BWROG-13014
February 19, 2013

SUBJECT: BWROG ECCS Suction Strainer Program
Closure of Technical Issue 12

Issue No. 12 – Spherical Zone of Influence – Closure Justification

Figure 1: Target Outside Spherical ZOI and Inside Directed Jet

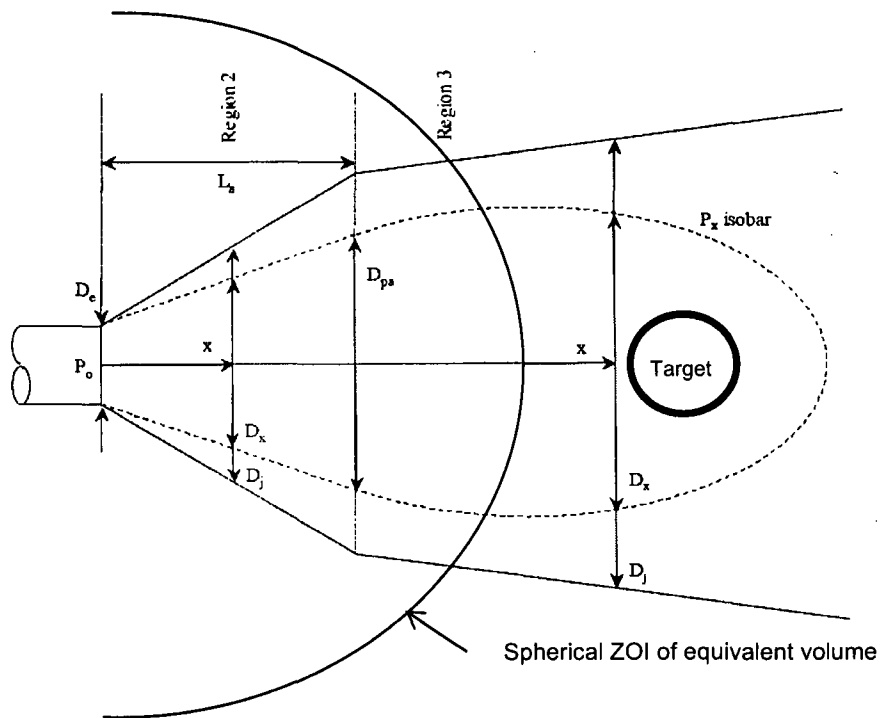
The NRC's concern is that, while a spherical ZOI may have maximized the quantity of debris, it may have precluded selection of a lesser amount of more problematic debris, such as micro-porous or calcium silicate insulation. Such problematic debris materials could be outside the spherical ZOI, but within the ZOI of a directed jet (see Figure 1).

We agree with the NRC staff on the conservatism inherent in the development and application of the spherical ZOI (e.g., reflection, energy dissipation, etc.) and also offer the following additional conservatisms relating to debris sources outside the sphere but within a directed jet:

1. Regarding calcium silicate problematic insulation, the radius of the BWR spherical ZOI is $6.4D$ (D is expressed in pipe diameter) and larger than the PWR ZOI of $5.45D$ with higher operating pressures and temperatures.

2. The directed jet theory assumes the break is fully offset with no interference from either the opposing jet or any structures with the effluent hitting a line of sight target greater than 24 feet away (12D or 24 feet is the radius of the spherical ZOI associated with Min-K and Microtherm, and assuming a 24 inch pipe break).

While the BWROG understands the NRC staff's concern over these potentially problematic materials, there is no intent by the BWROG to 1) develop new guidance on the size and shape of a directed jet ZOI, or 2) to specifically exclude or ignore problematic debris sources that could, if destroyed, transport to the ECCS suction strainer. The resolution strategy outlined on the BWROG slide 13 mentioned above was prepared in the event the NRC staff chose to revise its position on the acceptability of the spherical ZOI, which they have not.
